**Doc 9710, VAP/13**

INTERNATIONAL CIVIL  
AVIATION ORGANIZATION

## **VISUAL AIDS PANEL**

## **REPORT**

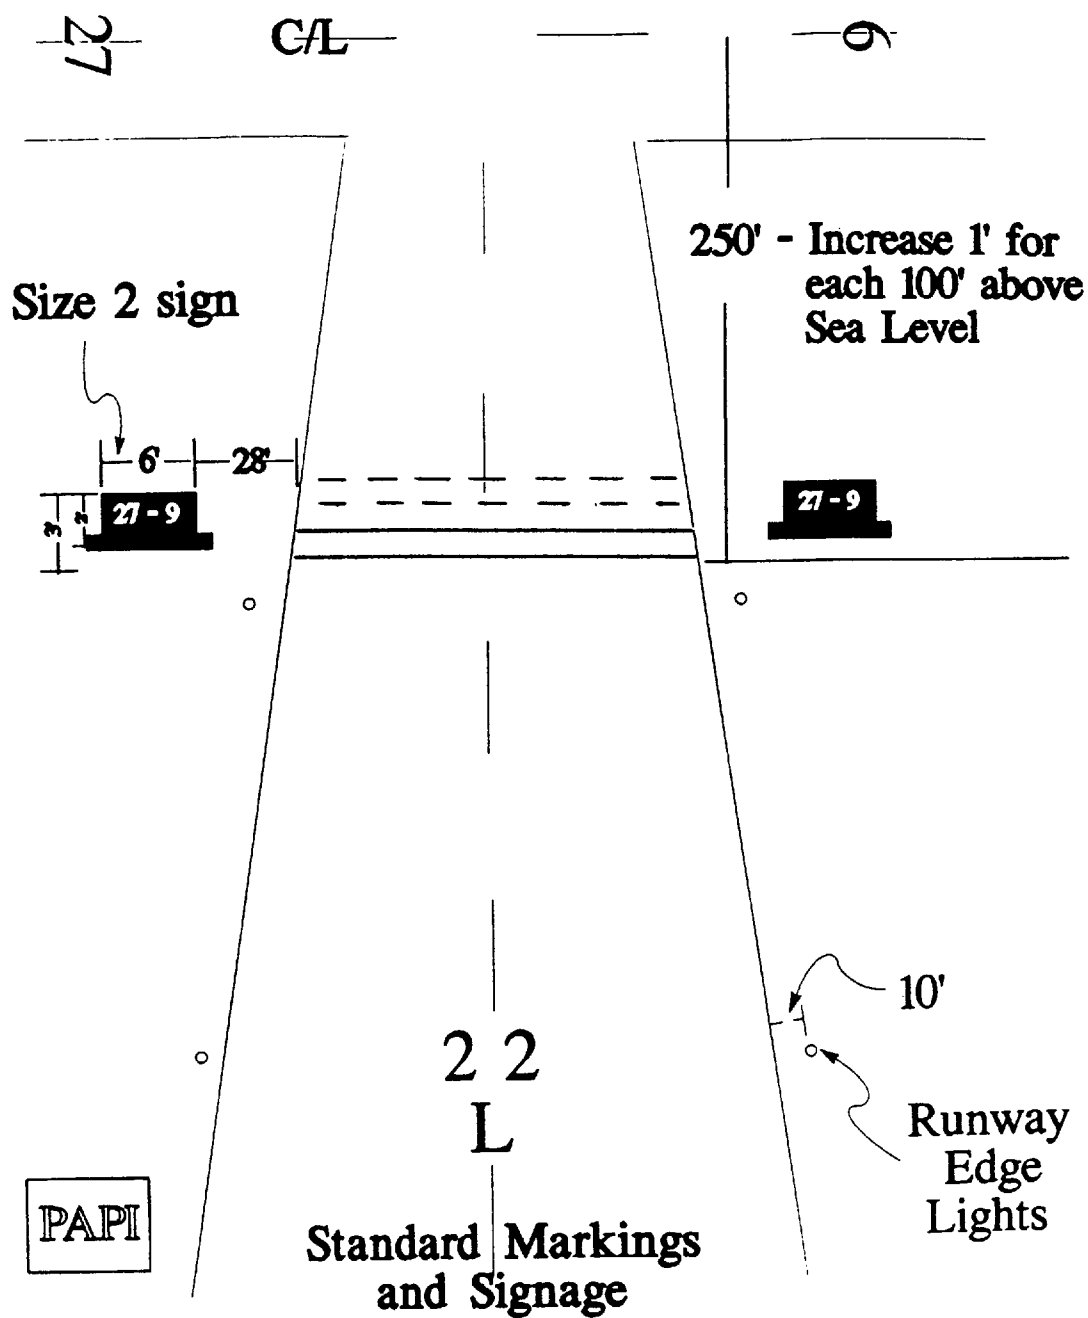
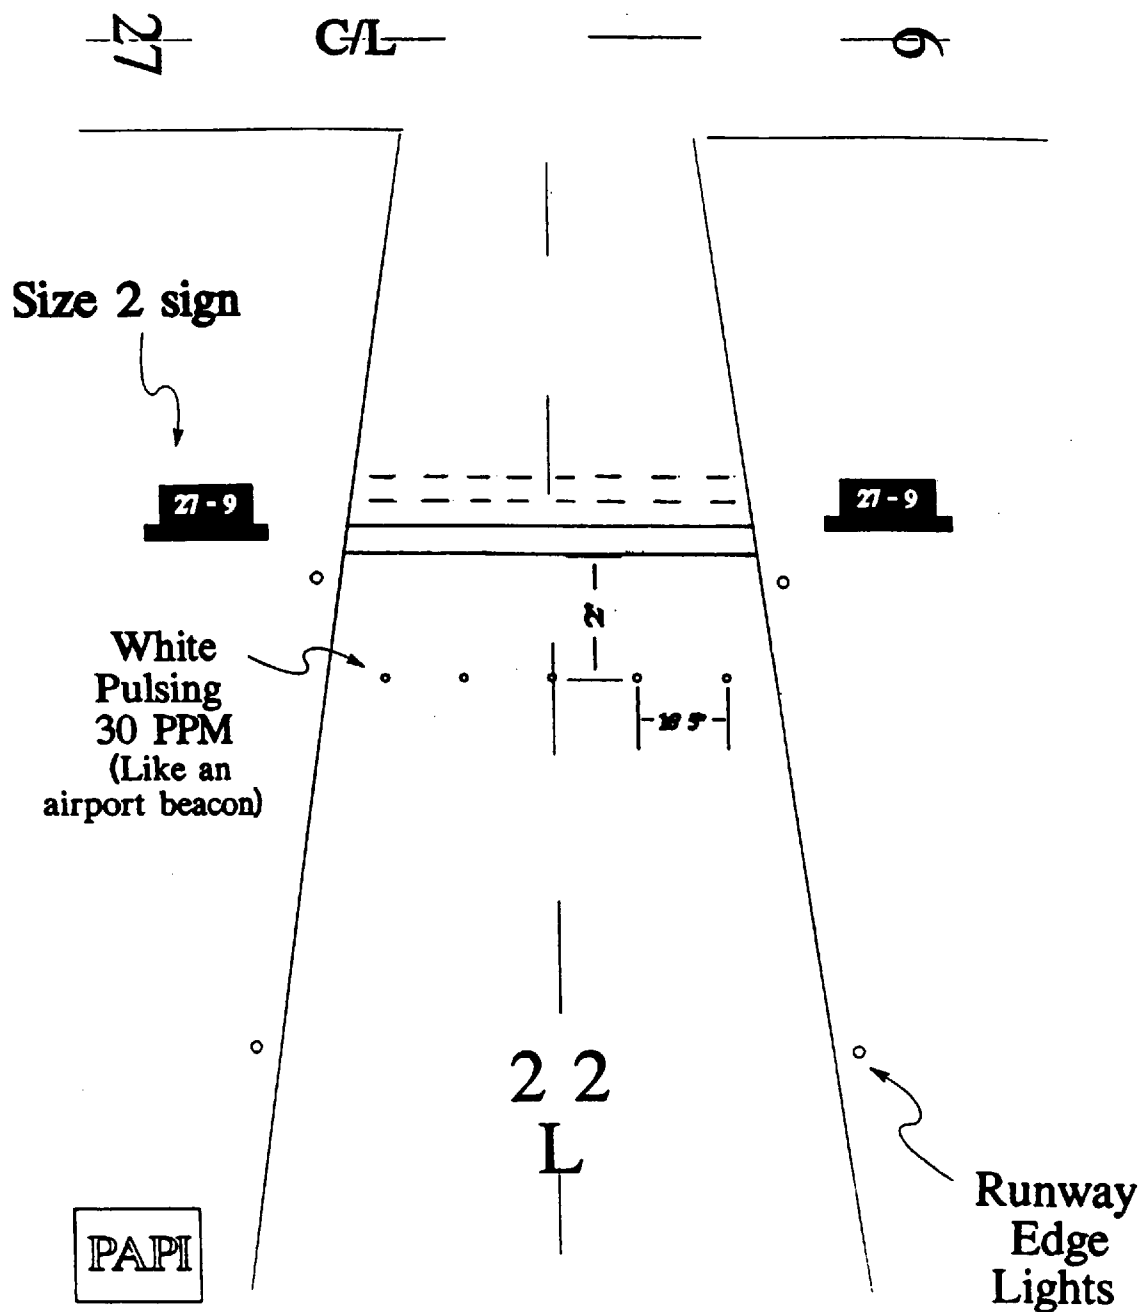
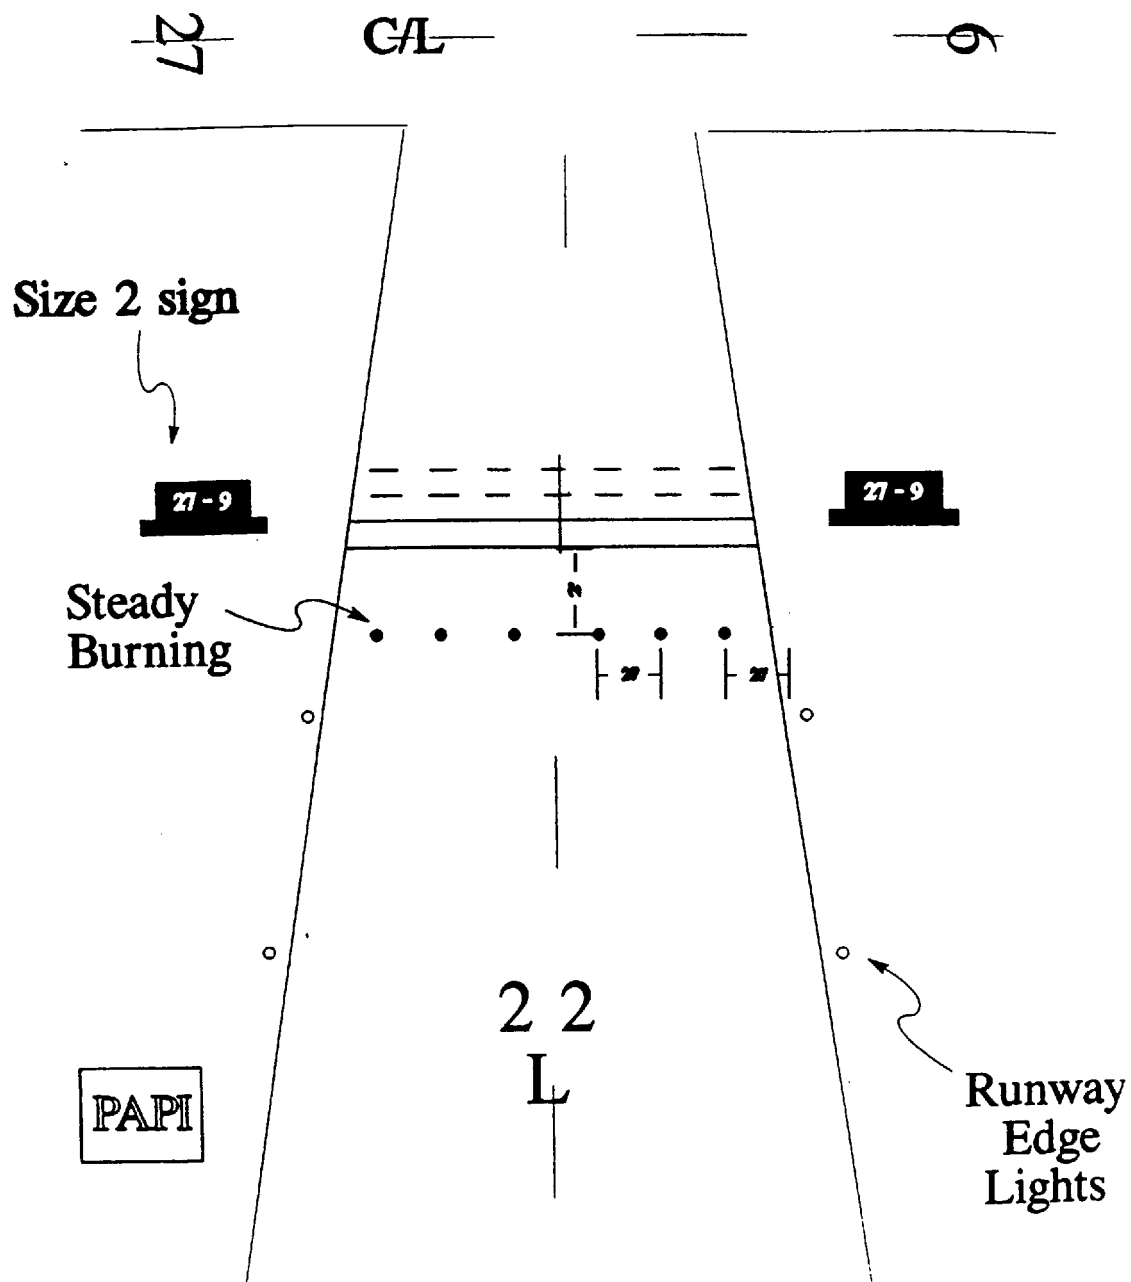
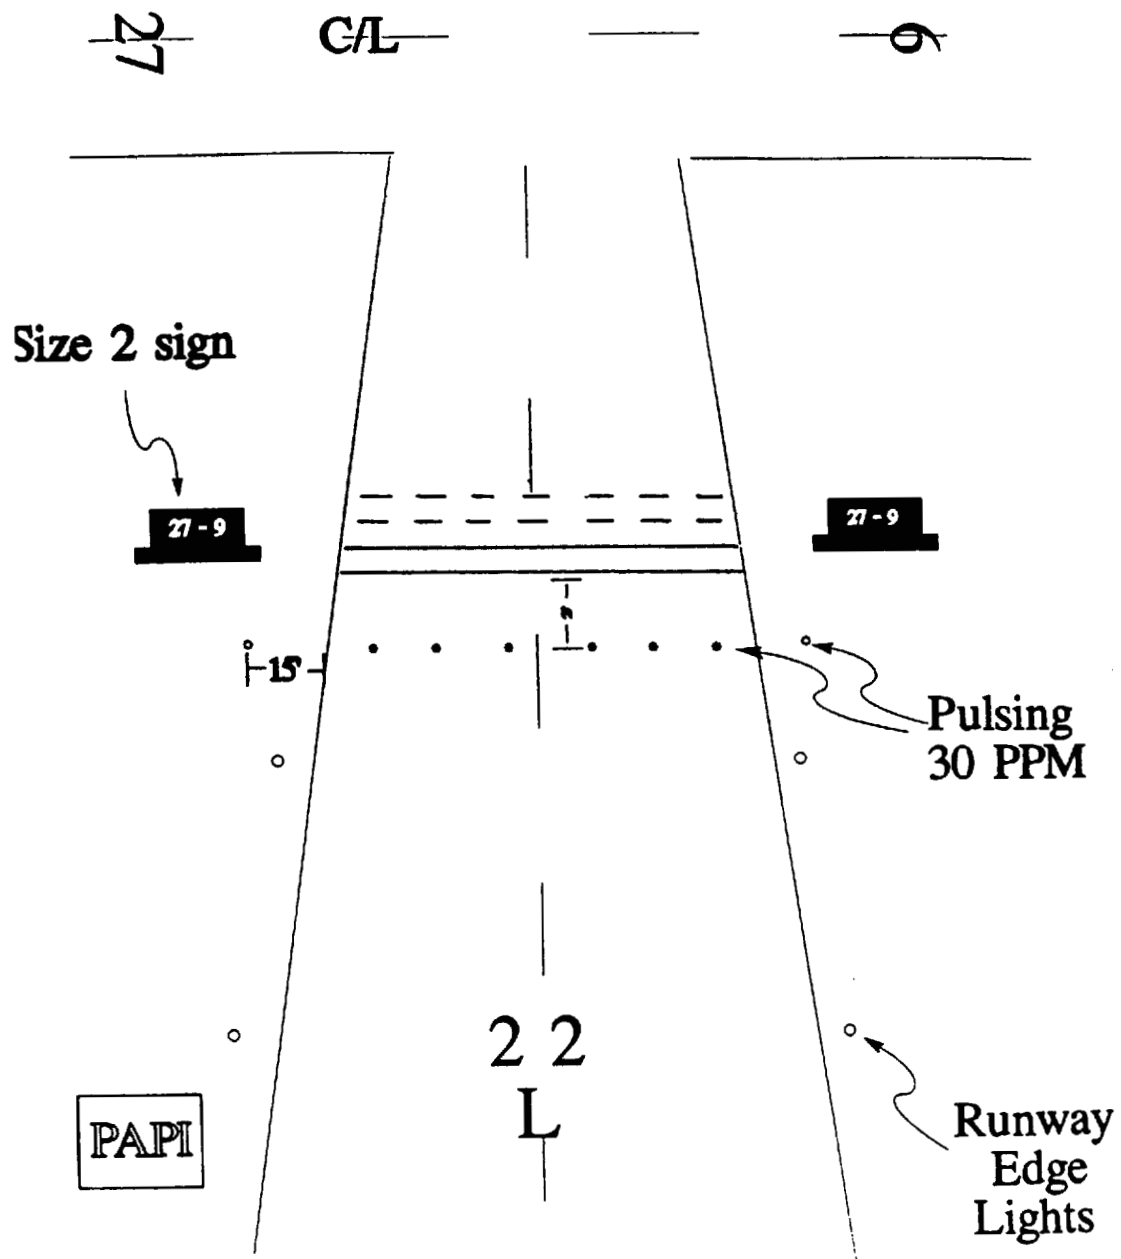
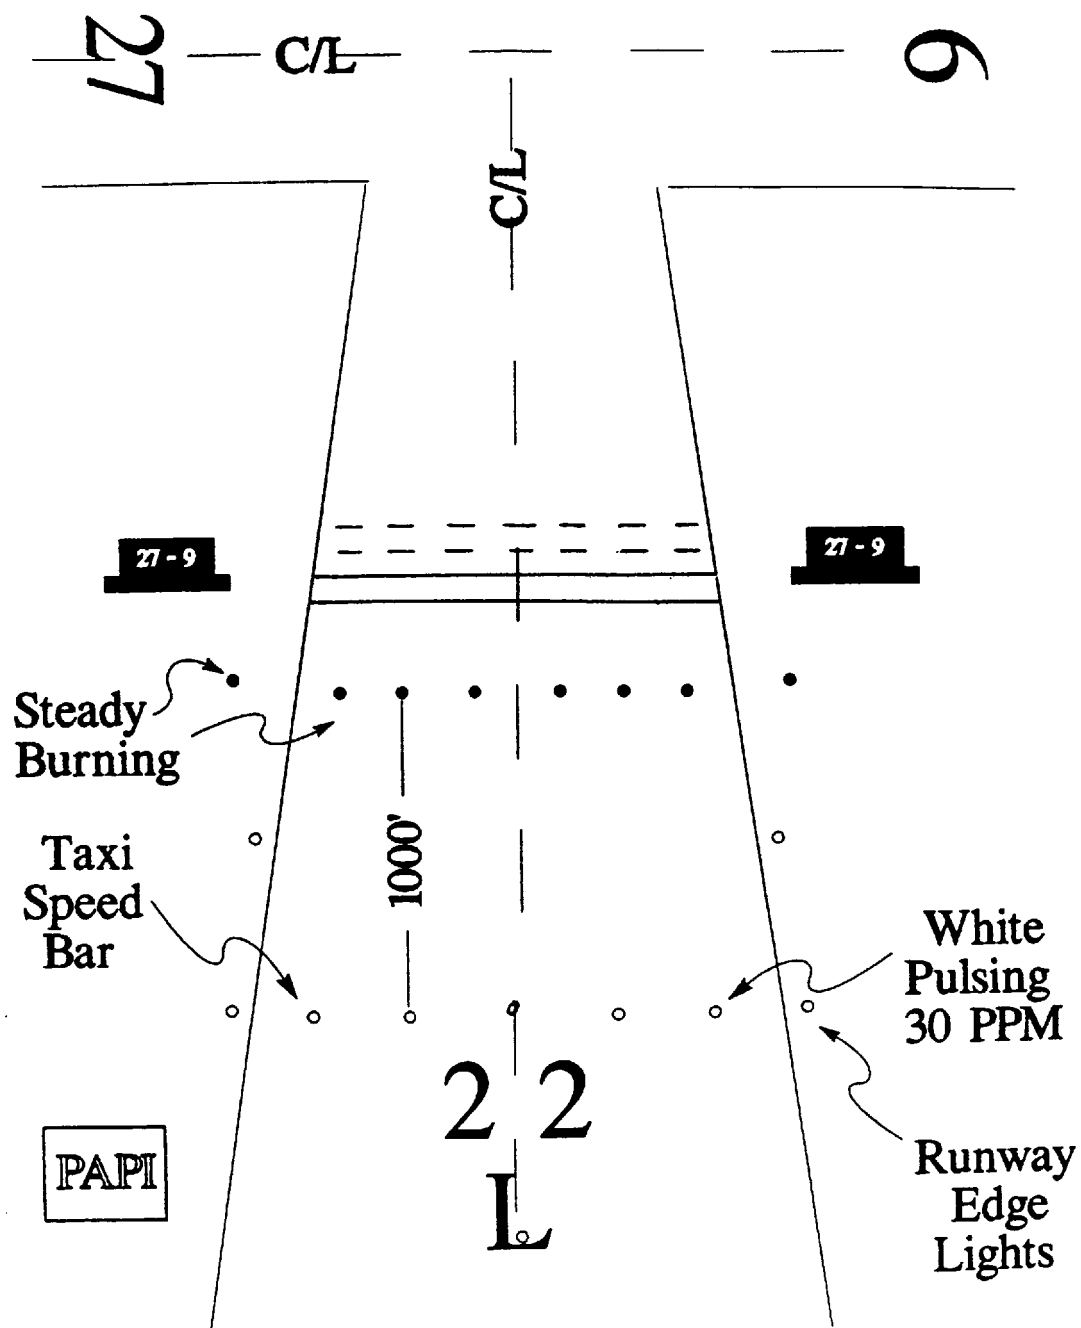
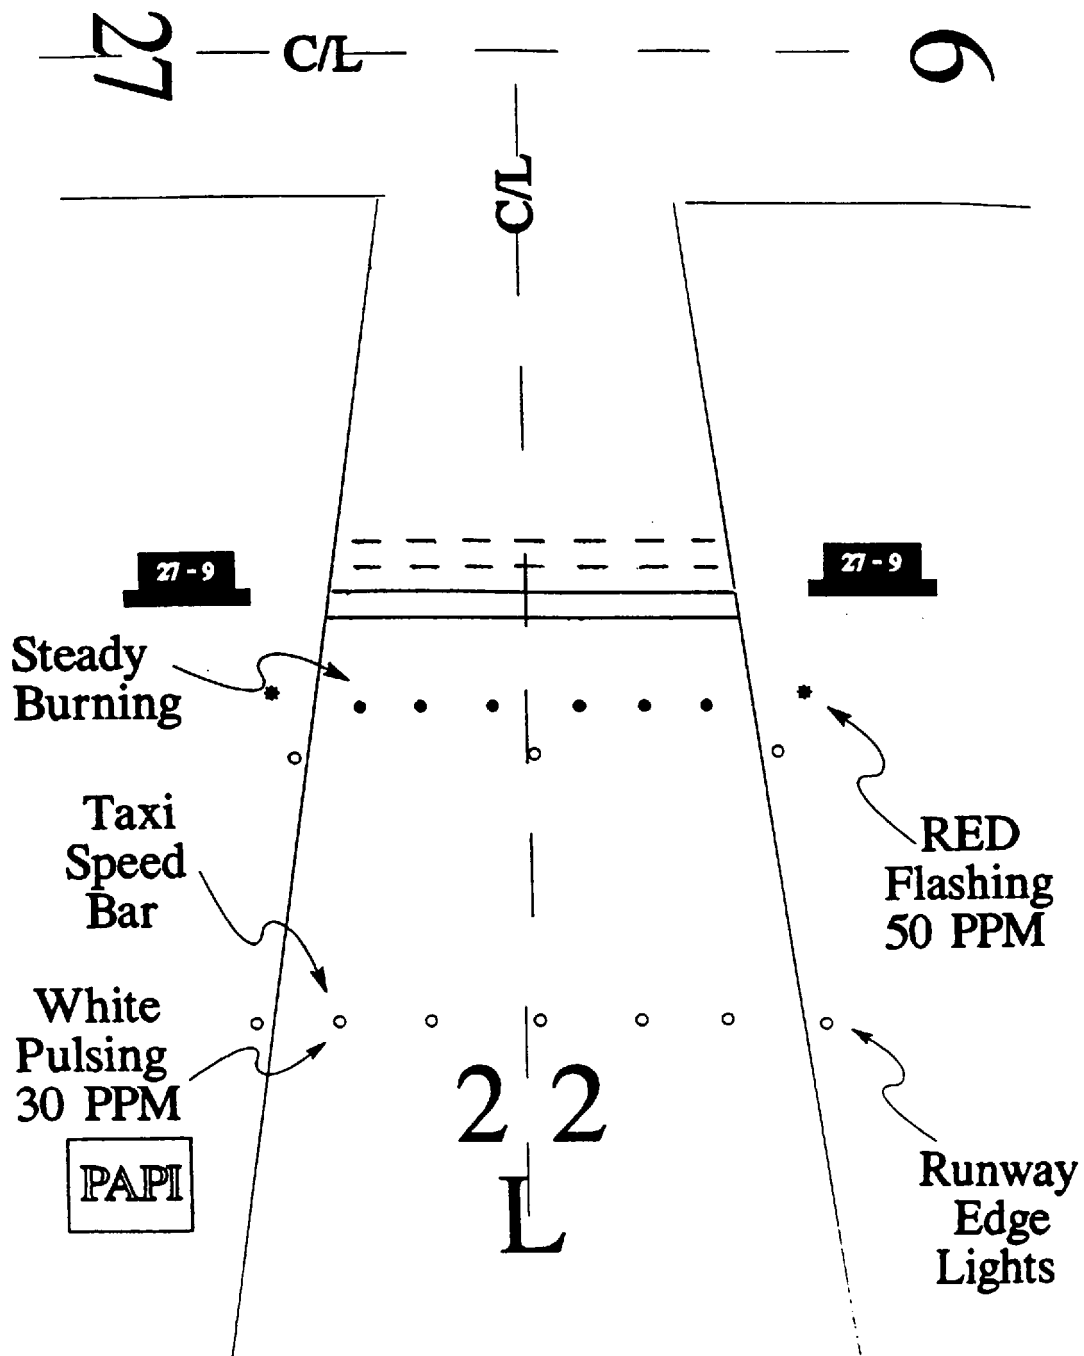
- Configuration 1: Holding position marking at the hold short position with a runway/runway intersection sign on both sides of the marking. No lighting system shown (Figure 1-3 below refers).

- Configuration 2: 5 flashing-white lights located 0.6 m before the marking spaced at 5 m (Figure 1-4 below refers).
- Configuration 3: 6 fixed-red lights located 0.6 m before the marking spaced at 6 m (Figure 1-5 below refers).

- Configuration 4: 6 flashing-red lights located 0.6 m before the marking spaced at 6 m supplemented by 1 flashing elevated-red light on each side of the marking (Figure 1-6 below refers).

- Configuration 5: 6 fixed-red lights located 0.6 m before the marking spaced at 6 m supplemented by 1 elevated fixed-red light on each side of the marking. In addition, a taxi speed bar consisting of 5 flashing-white lights spaced at 5 m was located 300 m before the red lights (Figure 1-7 below refers).

marking. In addition, a taxi speed bar consisting of 5 flashing-white lights spaced at 5 m was located 300 m before the red lights (Figure 1-8 below refers).

- a) Land and hold short position bar consisting of at least 6 unidirectional fixed-red lights (lights shall comply with Annex 14, Volume I, Appendix 2, Figure 2.9, Isocandela diagram for runway end light) located at right angle to the runway centre line and equally spaced at intervals not greater than 6 m supplemented by 1 elevated flashing-red light on each side of the land and hold short position; and
- b) Land and hold short alert bar consisting of at least 6 unidirectional flashing-white lights located at right angle to the runway centre line and equally spaced at intervals not greater than 6 m at a distance of 300 m prior to the land and hold short position (lights shall be simultaneously illuminated between 25 and 35 cycles per minute).

Figure 5-5B. Runway turn pad markings (not to scale)

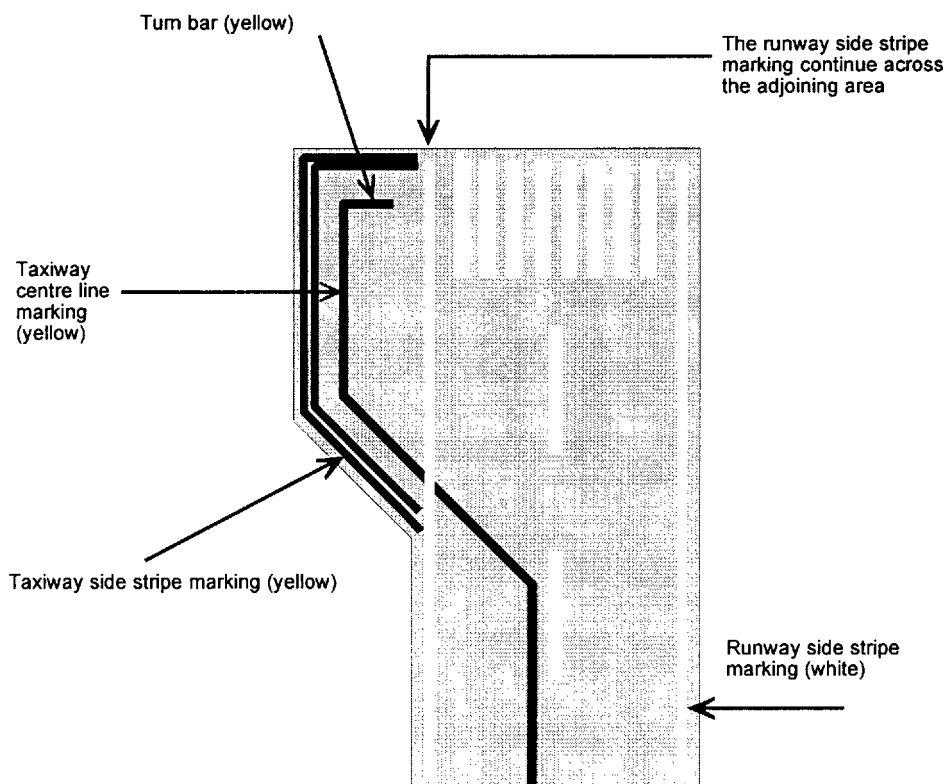
*Insert new figure as follows:*

7.2.1A The edges of the load-bearing surfaces of runway turn pads shall be marked by a taxi side stripe marking.

Figure 5-7A. Mandatory instruction marking

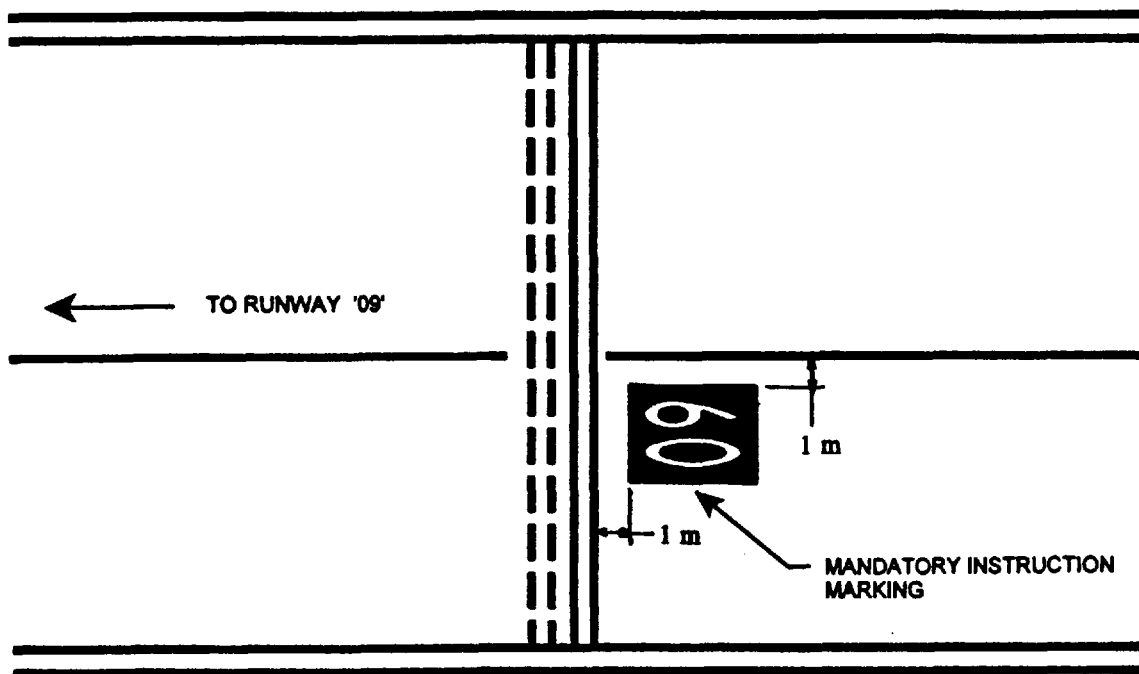
*Insert new figure as follows:*

5.2.14A.3 The mandatory instruction marking shall be located to the left of the taxiway centre line marking and on the holding side of the runway-holding position marking. The nearest edge of the marking shall be not closer than 1 m to the runway-holding position marking or the taxiway centre line marking. See Figure 5-7A.
